PLANNING COMMISSION AGENDA

Monday – July 23, 2007

DR 07-05 – 1st Student Bus Facility – The applicant requests approval to construct a bus barn facility on a 4.87 acre vacant lot located on the North side of SE Township, west of the Molalla Forest Road. The facility would consist of a 7,700 square foot building to house the drivers dispatch area, administration offices and a bus maintenance facility. **Page 47**

- STAFF REPORT -

SITE PLAN

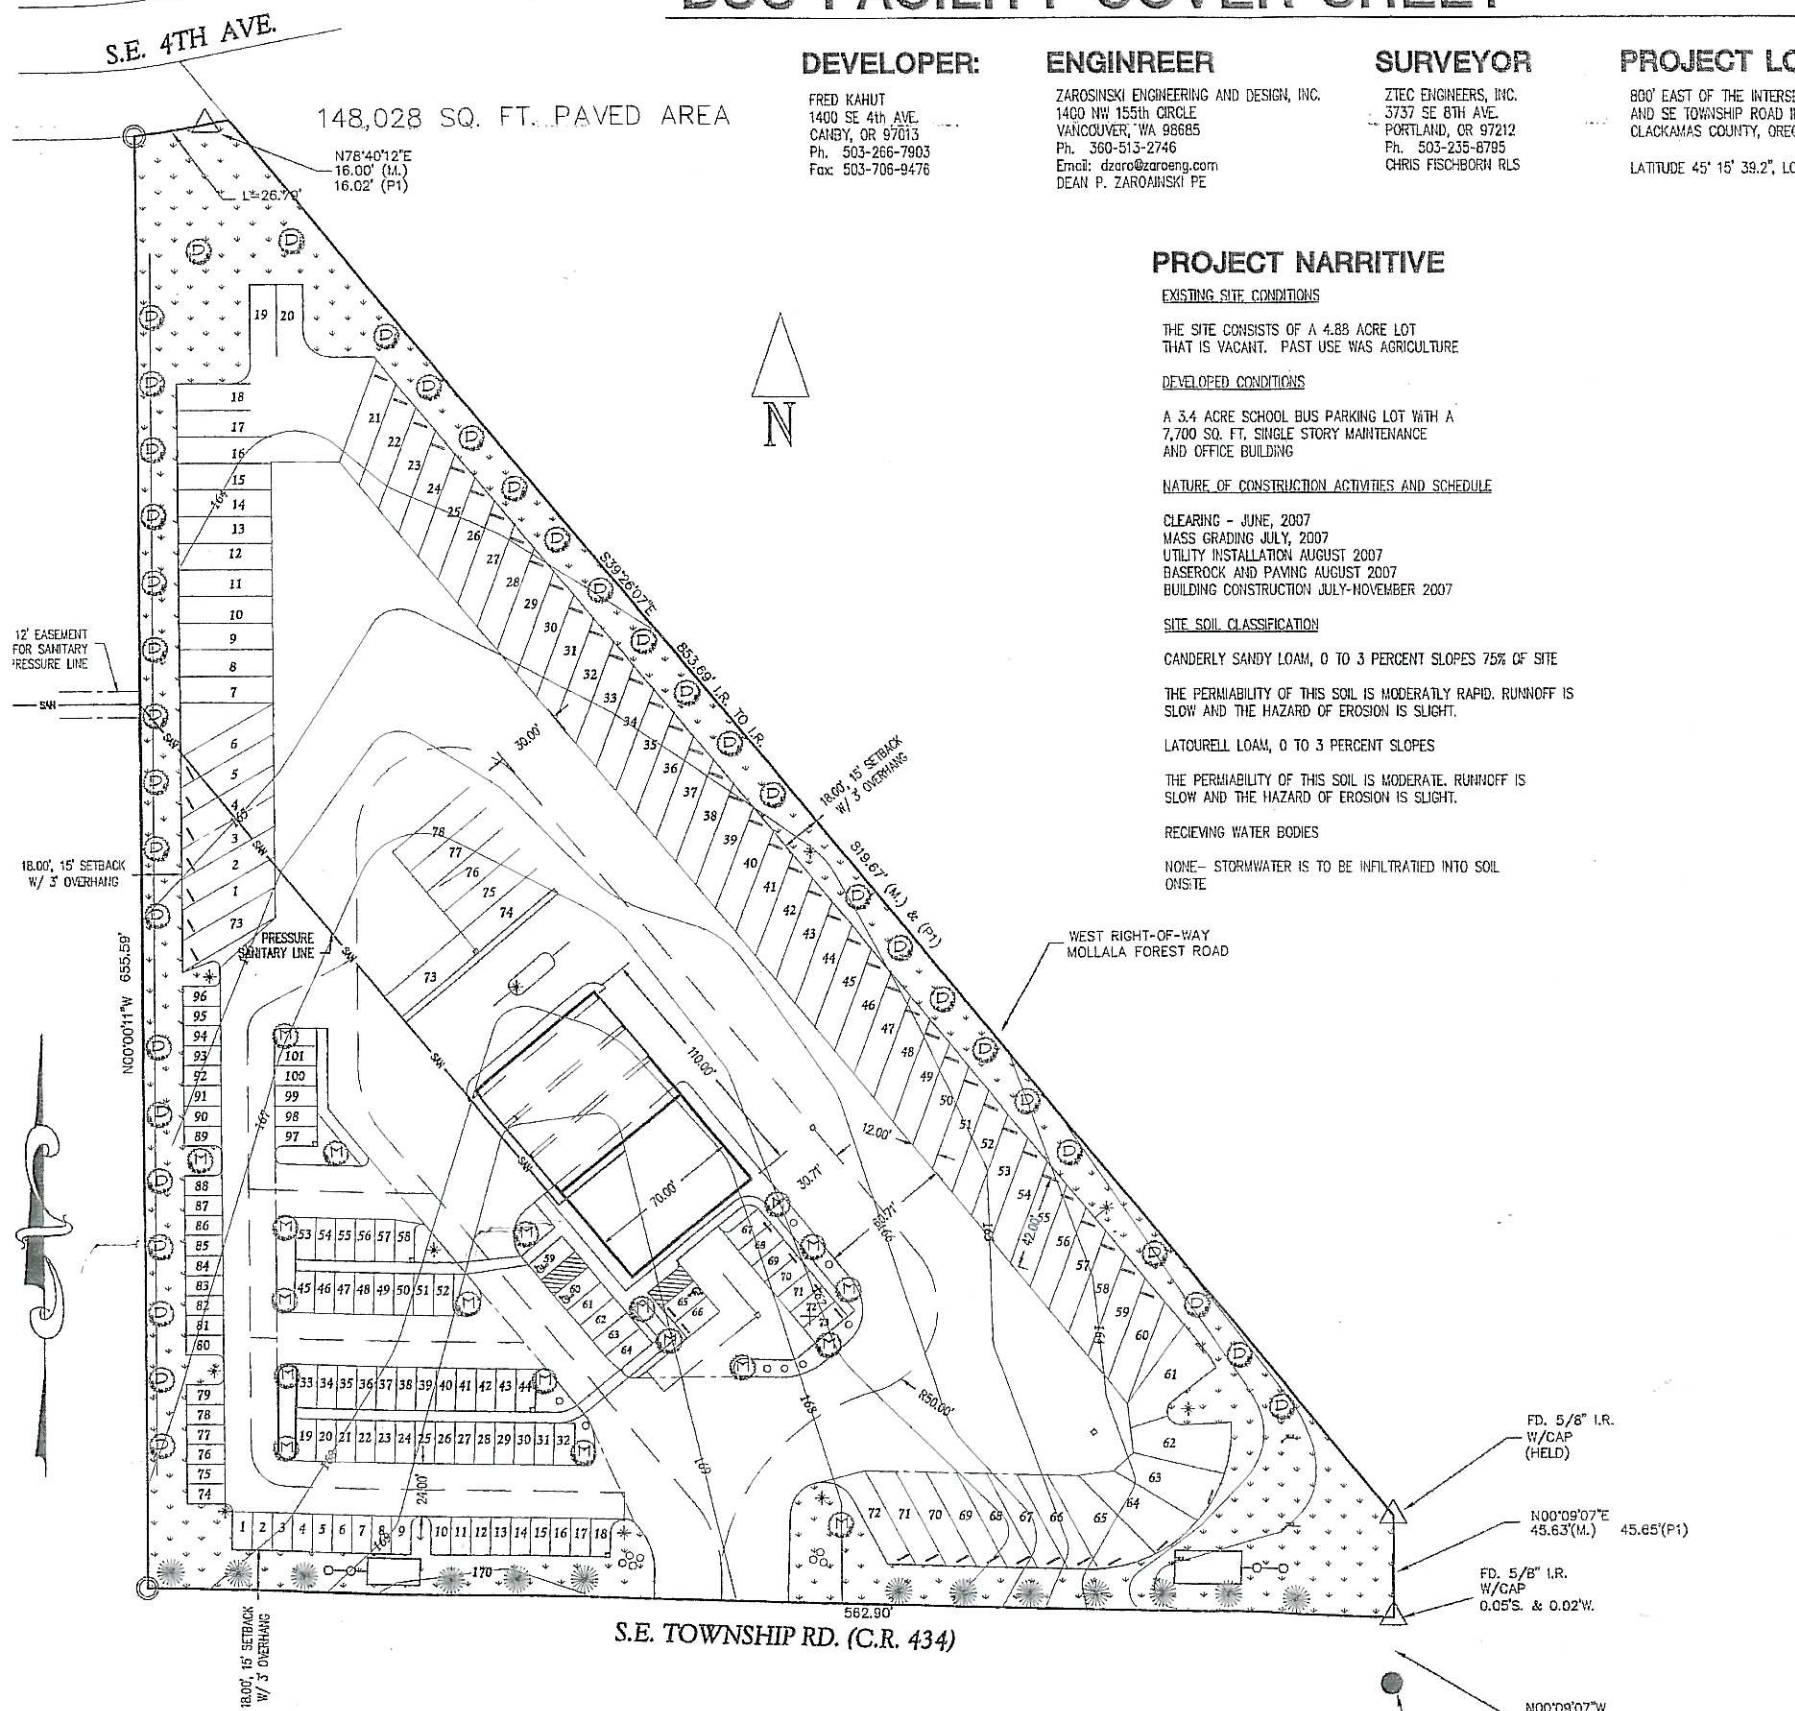
Minimum access width for industrial uses is 24 feet. The applicant has proposed a 60' wide access onto SE Township. The code limits driveway widths to 40', a condition has been added requiring the driveway to meet the maximum width. This access is to be aligned with the Baker Prairie Middle School access to the south.

Plans do not show proposed location of fire prevention vault or fire hydrant. (Condition #1)

Plans do not show proposed location of
fire PREVENTION VAULT OR fire HYDRANTS.

3. The access on SE Township Road is to be aligned with the Baker Prairie Middle School access drive and shown on construction plans
4. A detailed landscape construction plan shall be submitted with the building permit application. The detailed landscape plan shall show: the number of plants, plant spacing/location of planting, the type of plants, the size of plants, the schedule of planting, and irrigation plans. The landscape plan shall reflect the approved landscape plan submitted with the Design Review application.

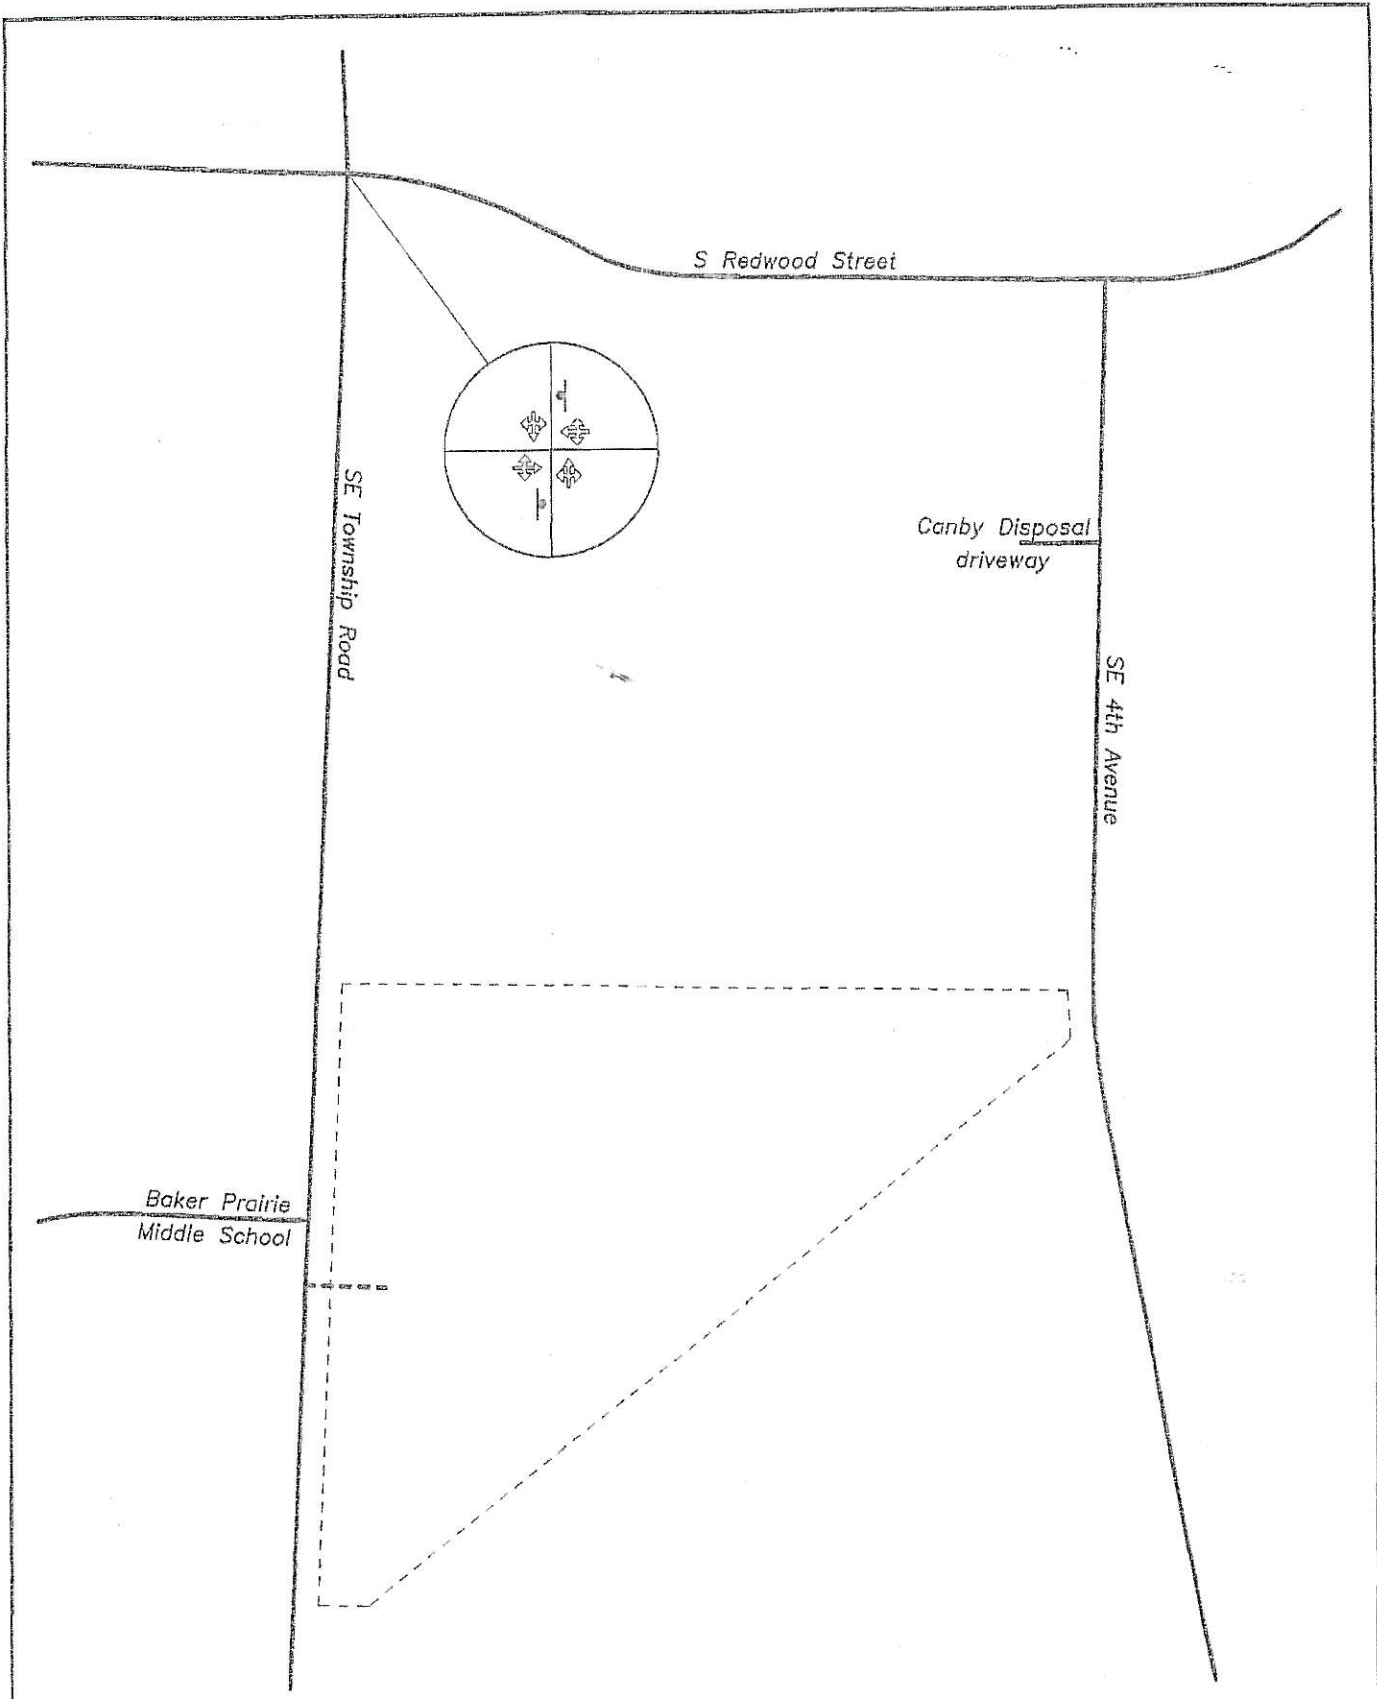
When SE Township Road becomes a three-lane section, this type of left-turning conflict will not occur, although traffic entering the site could still conflict with traffic entering the school. These conflicts would occur in the center turn lane rather than the travel lane. The conflicts would not block traffic at the access points, but could still interfere with traffic flow on SE Township Road as drivers slow to enter the turn lane behind the conflicts.

For these reasons, it is recommended that the access driveway to the site be aligned with the school road.

SUBMITAL	TENTATIVE SUBDIVISION PLAT - STRUBLE	JOB NO.:	N3561-1
TITLE	FOR: STRUBLE MANUFACTURING	DWG. NO.:	N35611C1
		SCALE:	1" = 50'
		SHEET:	59
			C1

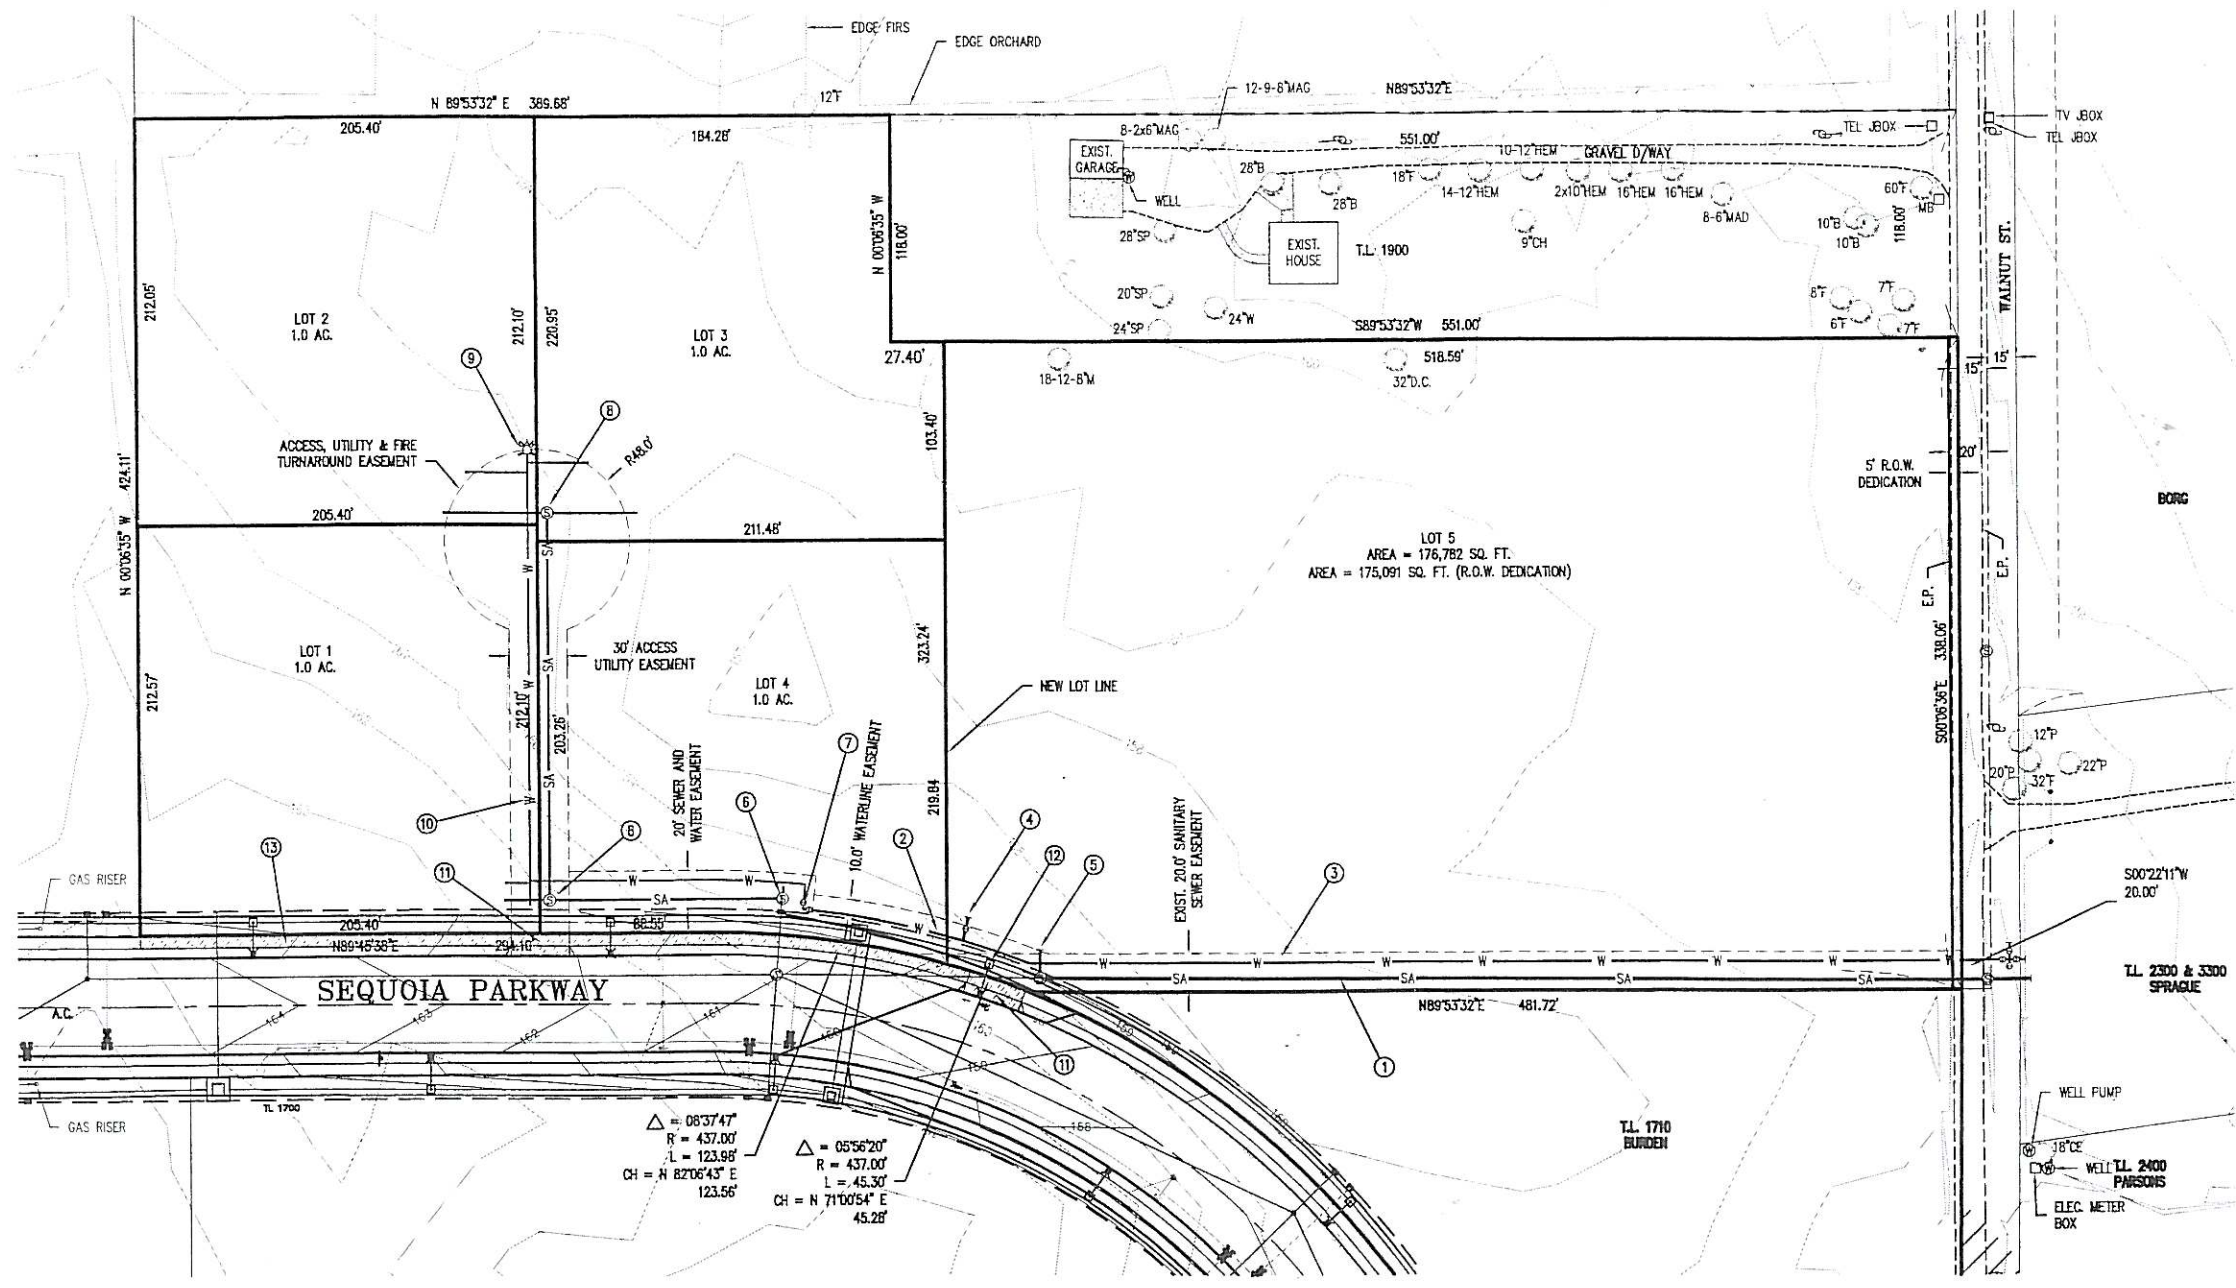
1. No roadway cutting on Sequoia Parkway should be allowed except at the new driveway connection. An existing 8" sanitary sewer stub is available to serve this site.
2. A 6-foot wide sidewalks should be constructed along the entire site frontage with Sequoia Parkway including landscaping in the existing 5 -foot wide planter strip.

Electrical Primary will need to be extended through the
development @ developer's expense See attached
conceptual drawing
